**REVISION 007 TO A  
INVITATION TO TENDER**

<b>Title:</b> Fire Protection, Systems and Building Repairs- Lower Fort Garry National Historic Site	
<b>Solicitation No.:</b> 5P468-22-0065/A	<b>Date:</b> September 16, 2022
<b>Amendment No.:</b> 007	
<b>Client Reference No.:</b> 2171.4	
<b>GETS Reference No.:</b> PW-22-01003821

## Amendment 007

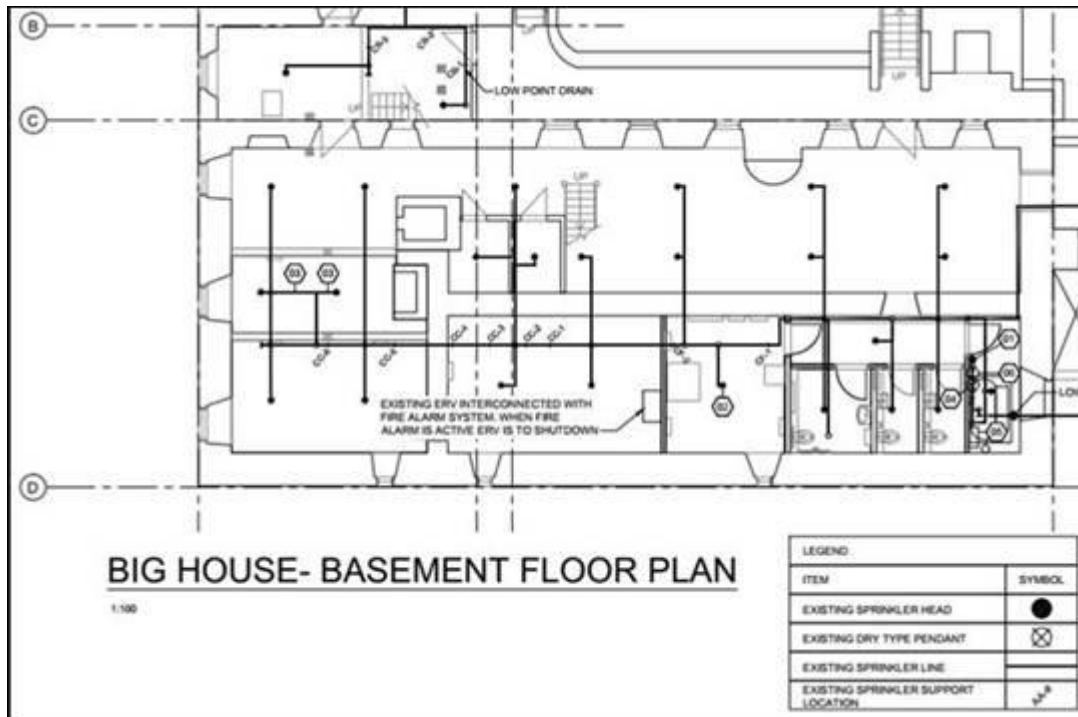
**Q17** Potter requires the project form, attached to be filled out in order to properly quote/size the replacement Nitrogen generators. Is this information available? Can it be provided? Potter is suggesting that even though we may have the existing generator information, they want to confirm that sizing is proper.

**A17** This information is available in the Nitrogen Generator Inspection report in the SMS final report appendix. See DSP4\_22\_0065 *Nitrogen Generator reports*

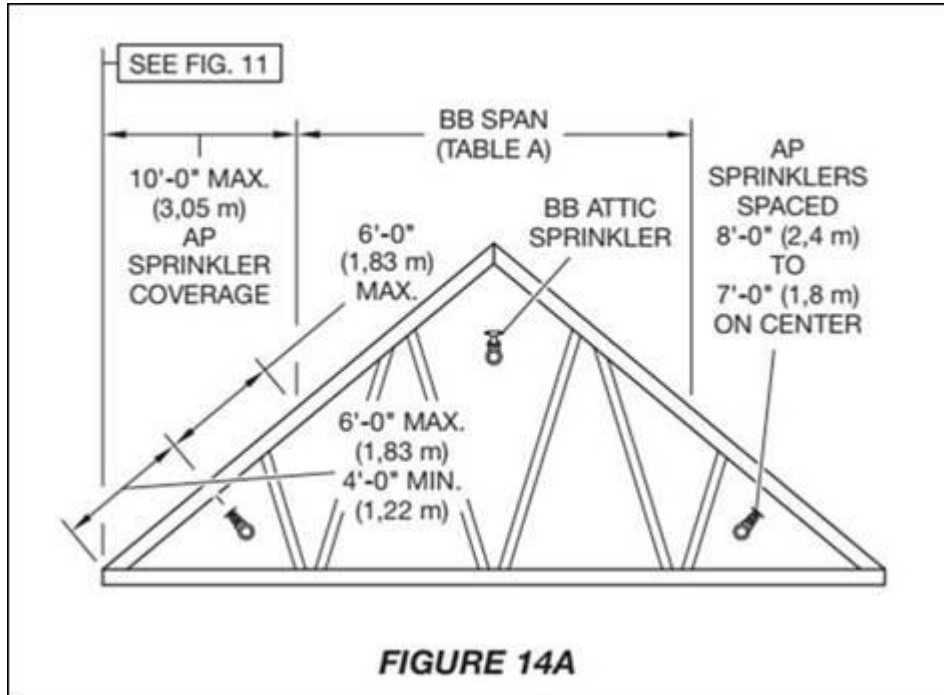
**Q20** Drawing M1.2...Note 01 – install sprinkler head a distance of 1500 mm away from attic wall. Moving the sprinkler heads the requested distance from the attic wall creates a cold solder situation with other existing sprinkler heads adjacent to the head to be moved. Can you advise on the purpose of the relocation/move and advise on the potential ramifications? This is a common note on other drawings as well.

**A20** The sprinklers are currently not installed within the manufacturer's installation specifications. Please see below for a figure regarding installation details.
